ADDENDUM NO. 03

LOPER ELEMENTARY SCHOOL RENOVATION

ADDENDUM NO. THREE

PROJECT: Shelbyville Central Schools – 2022 Loper Elementary Renovation

EP101A

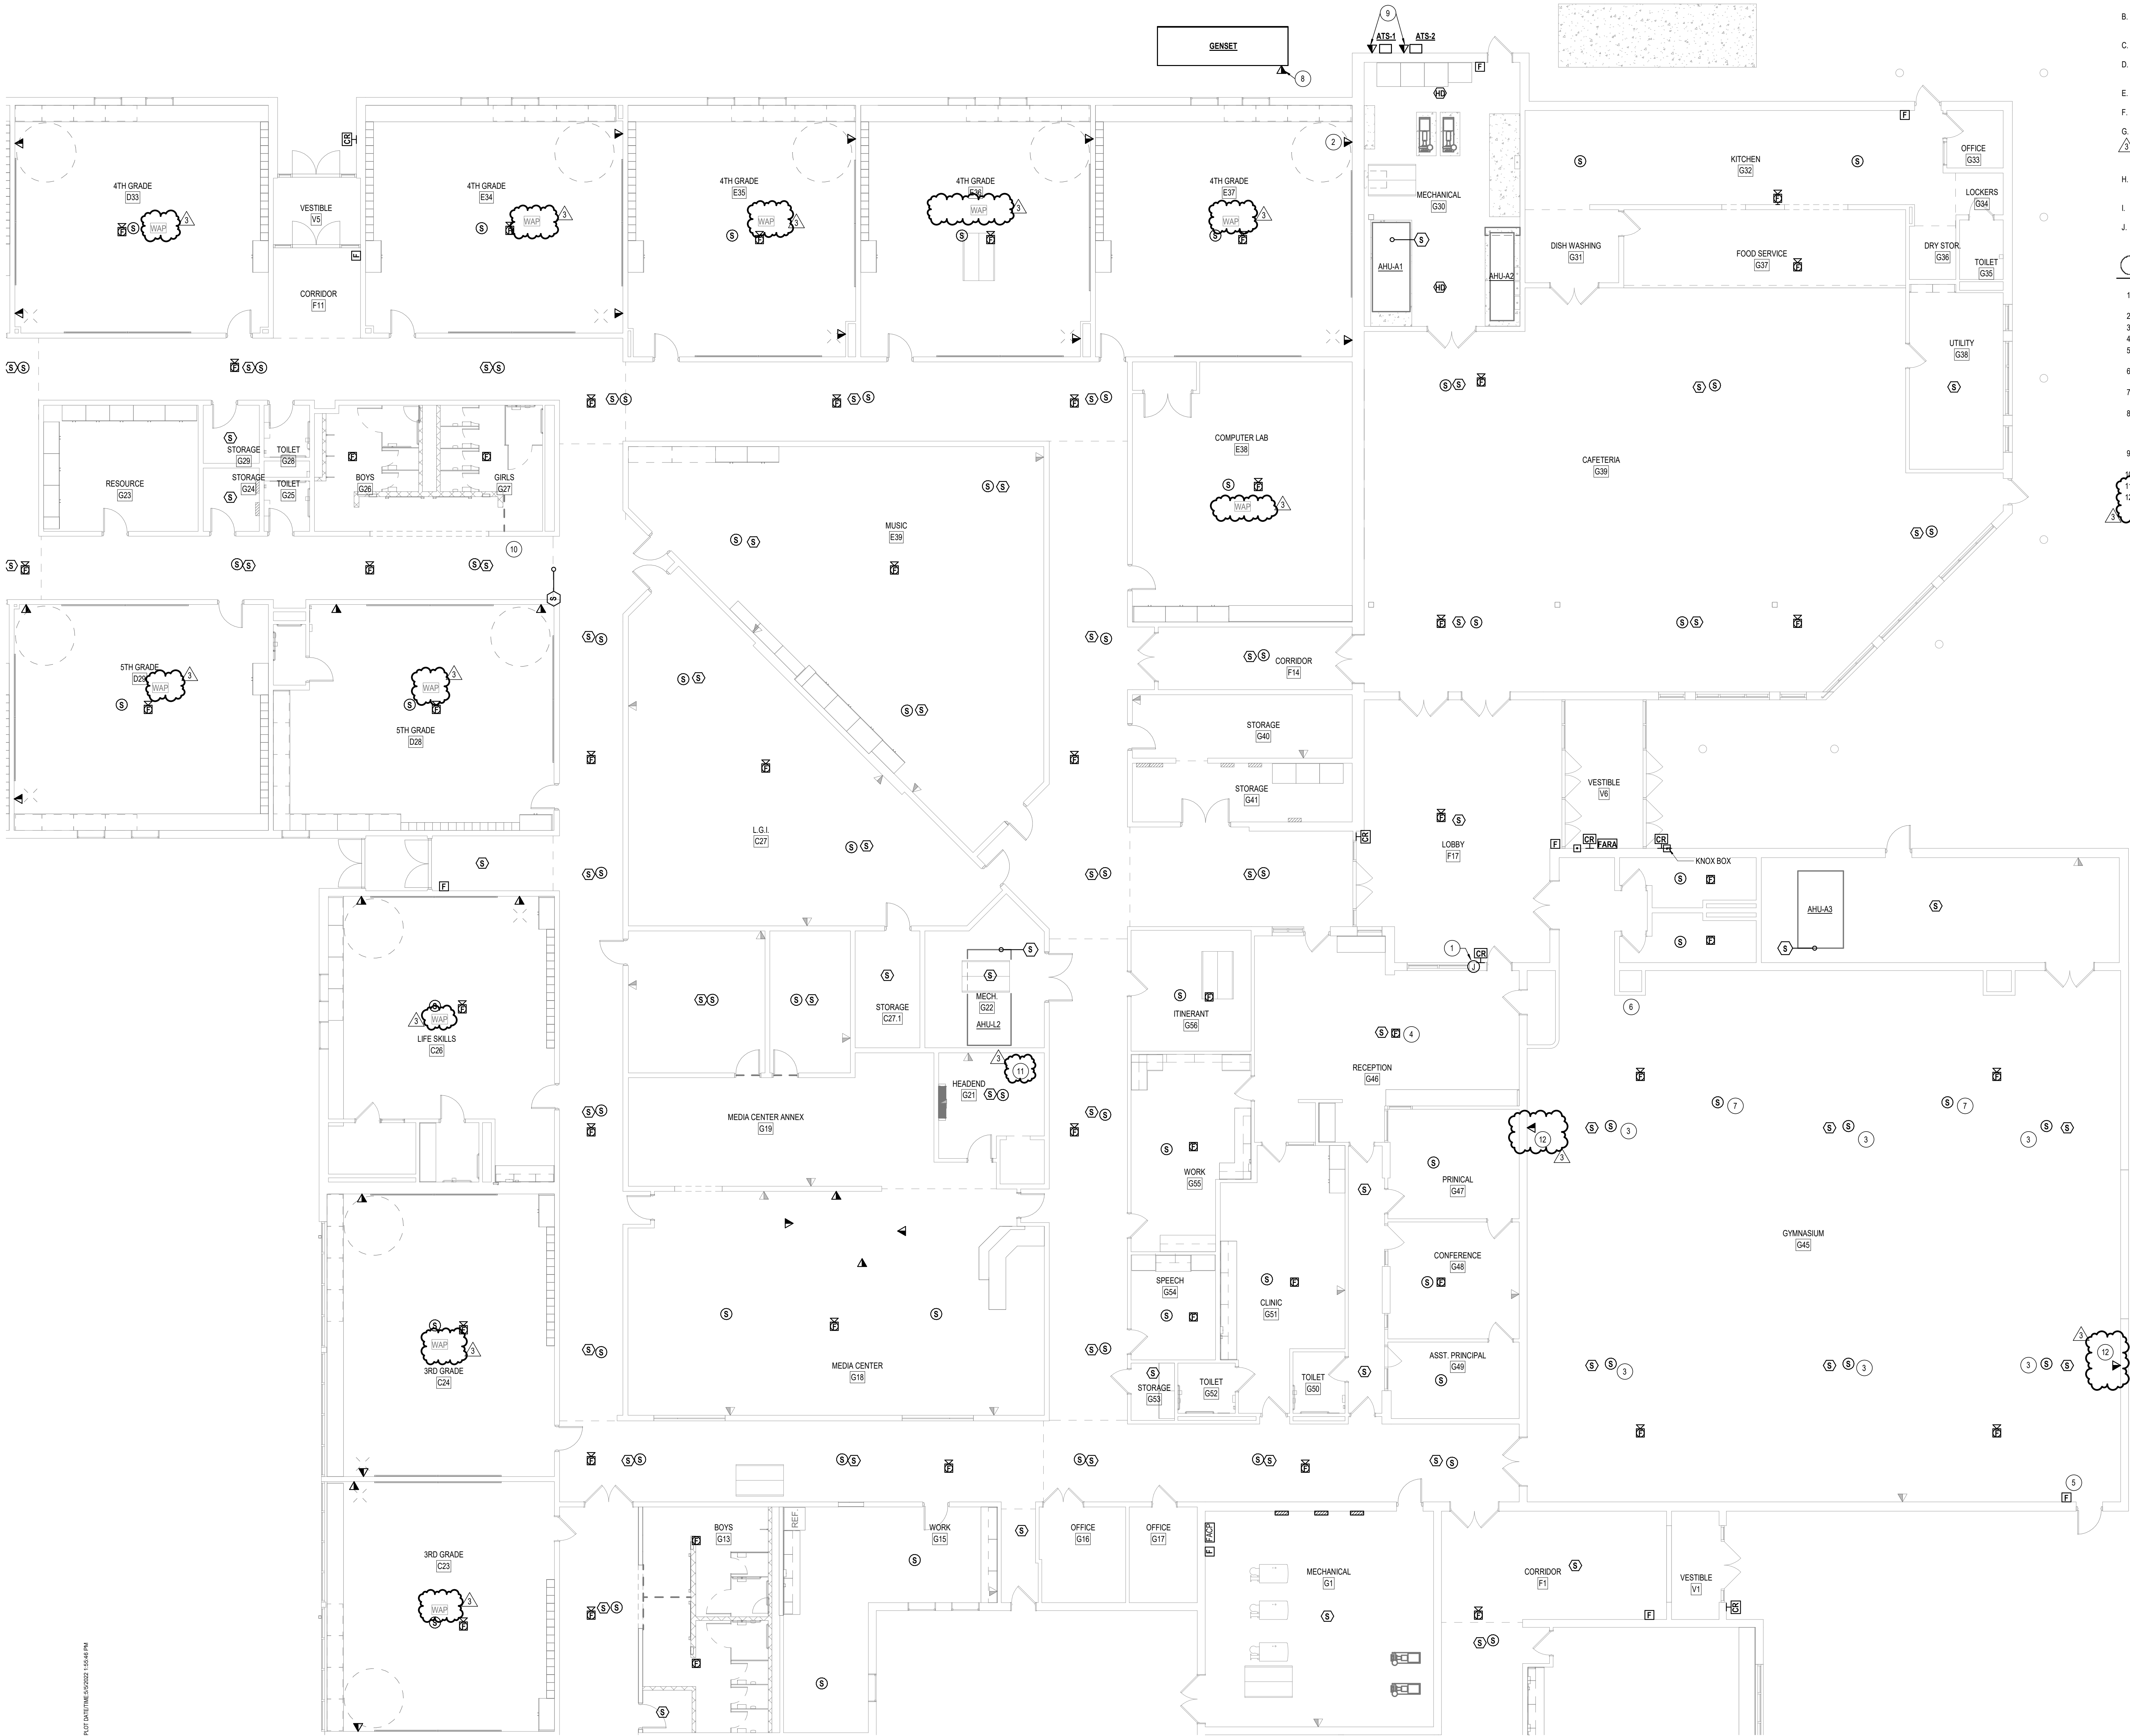
- A. Motorized equipment schedule updated for CWP sizes
- 3.07 EP101A- First Floor Power Plan – Unit A
 - A. Plan note 1 added for mechanical equipment HUH-G46
 - B. Plan note 29 added for CWP circuitry
- 3.08 ED101A – First Floor Demo Plan – Unit A
 - A. Shading updated for existing to remain data outlets.
 - B. Plan note 14 added for CWP circuitry
- 3.09 ET101A – First Floor Technology Plan – Unit A
 - A. Added existing WAP locations.
 - B. Updated plan note G to call out number of data cables from data outlets.
 - C. Added note calling out MDF room.
 - D. Added data for scoreboards.
- 3.010 ET101B – First Floor Technology Plan – Unit B
 - A. Added existing WAP locations.
 - B. Updated plan note G to call out number of data cables from data outlets.
 - C. Added note calling out IDF room.
- 3.011 ET101C – First Floor Technology Plan – Unit C
 - A. Added existing WAP locations
